APPEAL SUMMARY

Appeal ID: 20546	Project Address: 1600 SW Salmon St
Hearing Date: 6/19/19	Appellant Name: Tom Jaleski
Case No.: B-017	Appellant Phone: 503.488.5651
Appeal Type: Building	Plans Examiner/Inspector: Jody Orrison
Project Type: commercial	Stories: 6 Occupancy: A-2, A-3, B, E, S-1 Construction Type: I-B
Building/Business Name: Lincoln High School	Fire Sprinklers: Yes - Throughout
Appeal Involves: Erection of a new structure	LUR or Permit Application No.:
Plan Submitted Option: pdf [File 1] [File 2]	Proposed use: High School - Main Building

APPEAL INFORMATION SHEET

LINCOLN HIGH SCHOOL REPLACEMENT

4 STAIR 1 - WEST
1/4" = 1'-0"

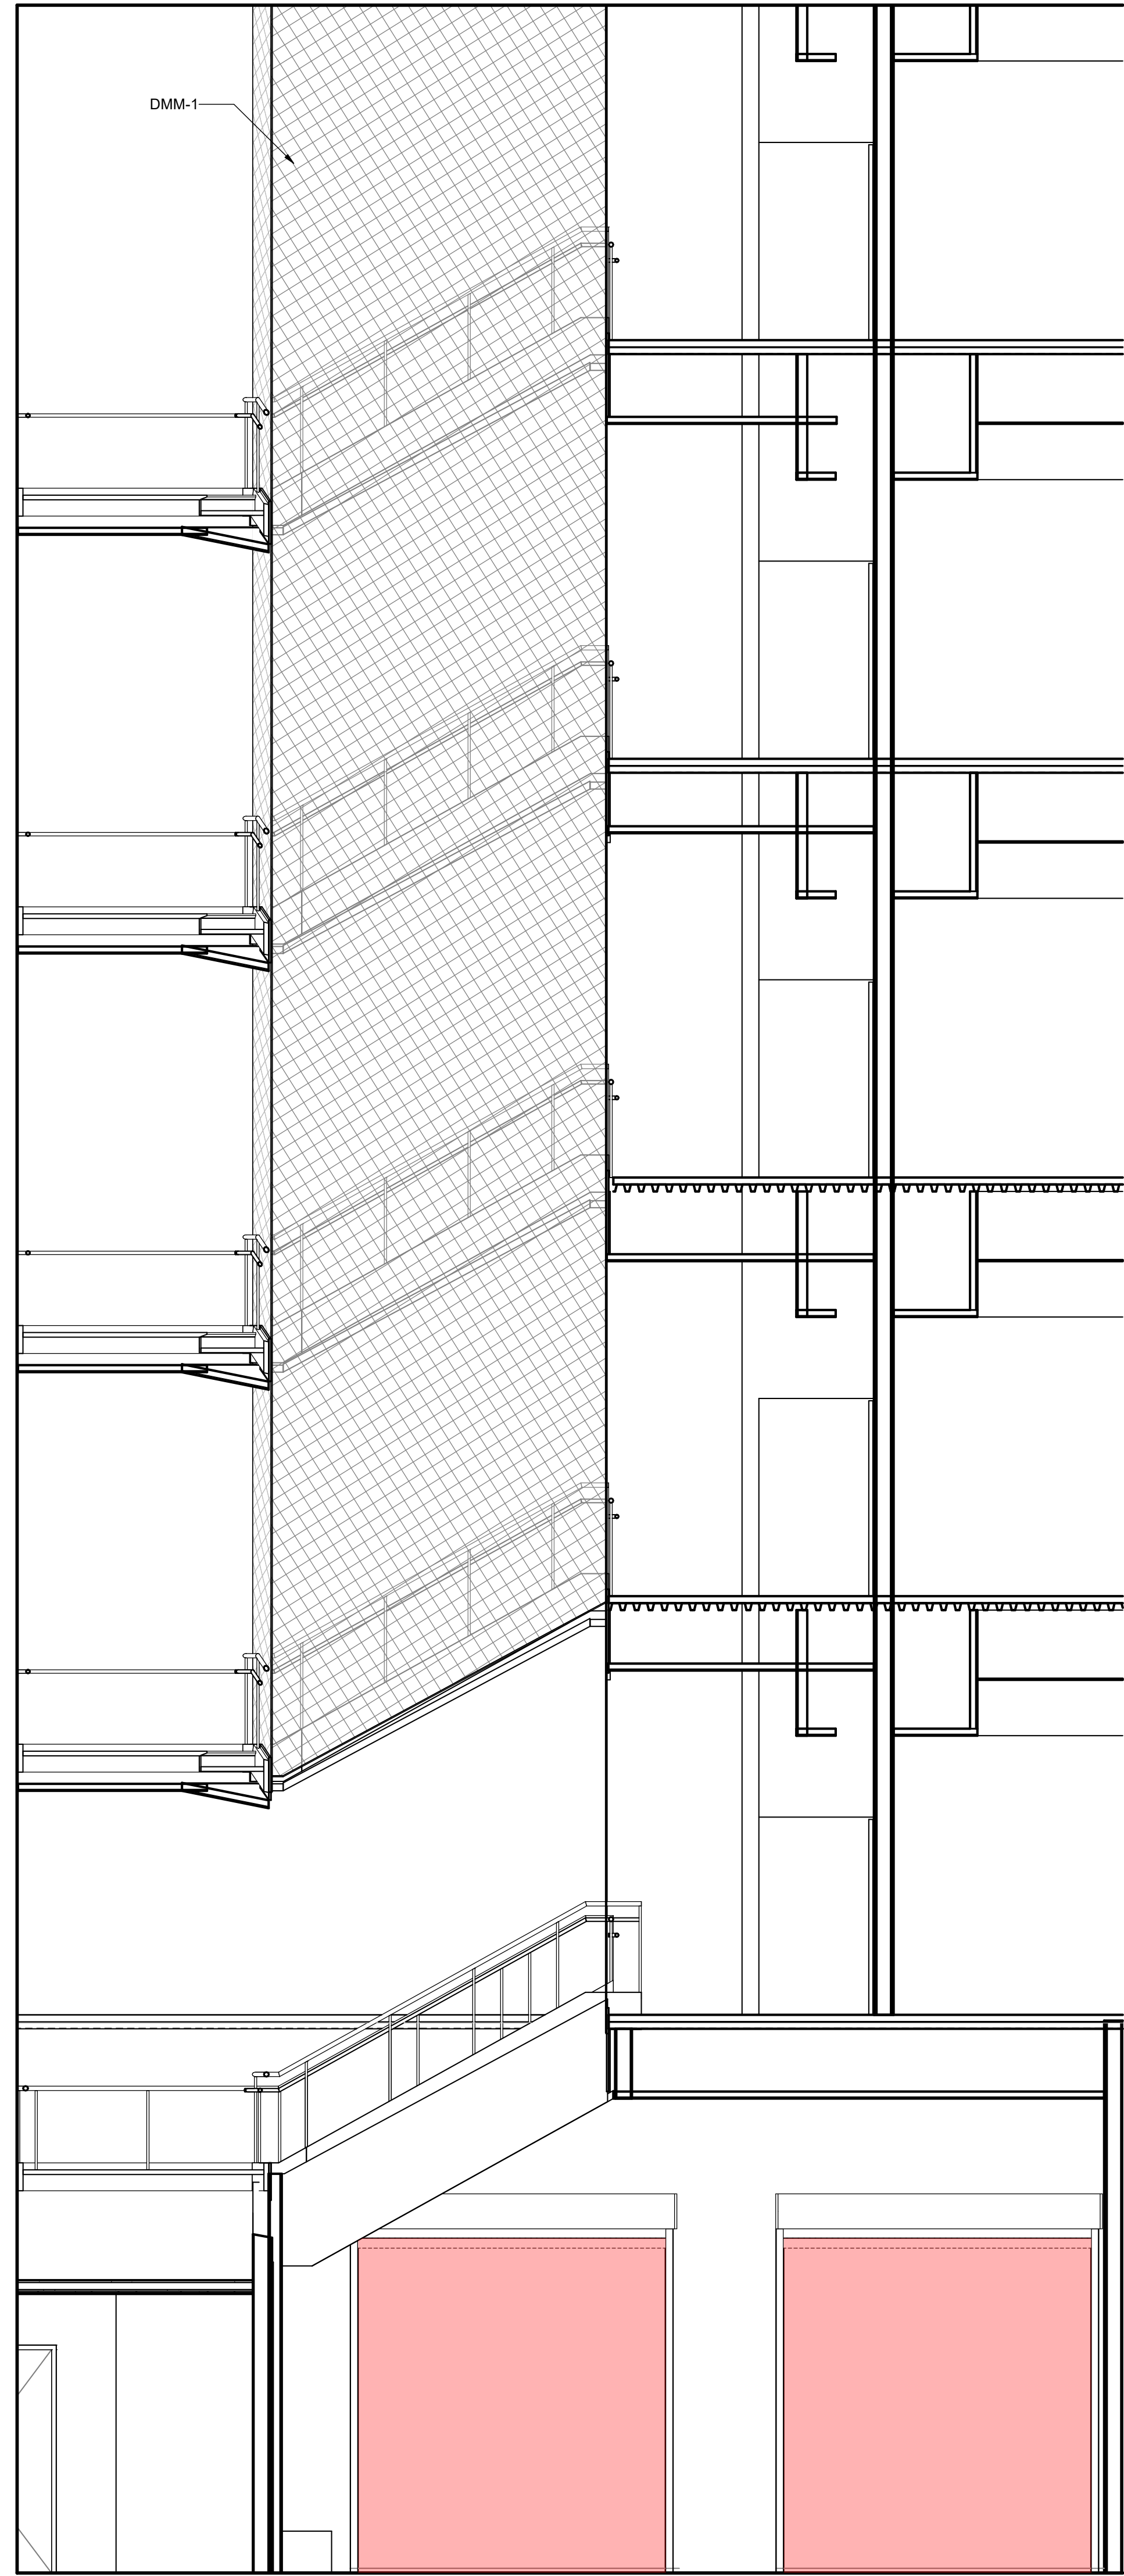
- o Two openings located on west wall of enclosure at Level 01.
- o Each protected with a 3-hour fire shutter meeting UL 10B (equivalent) and UL 1784, and provided with an automatic-closing device and smoke detection.
- o Both shutters are 11-ft wide by 12-ft tall (132 sf).
- o One of the shutters will include a 3-ft wide by 8-ft tall integral person door.

2b. The 3-hour fire-resistance-rated fire shutters located on the west wall of the Stair 4 enclosure and on the west wall of the Stair 1 are not prescriptively allowed. The shutters will provide equivalent fire life safety as compared to the code requirements of a stairway enclosure in a fire event by meeting, and in some requirements exceeding, the opening protective provisions of Chapter 7 as follows:

2. Openings in (2) two hour fire rated stair enclosures: Hold for additional information.
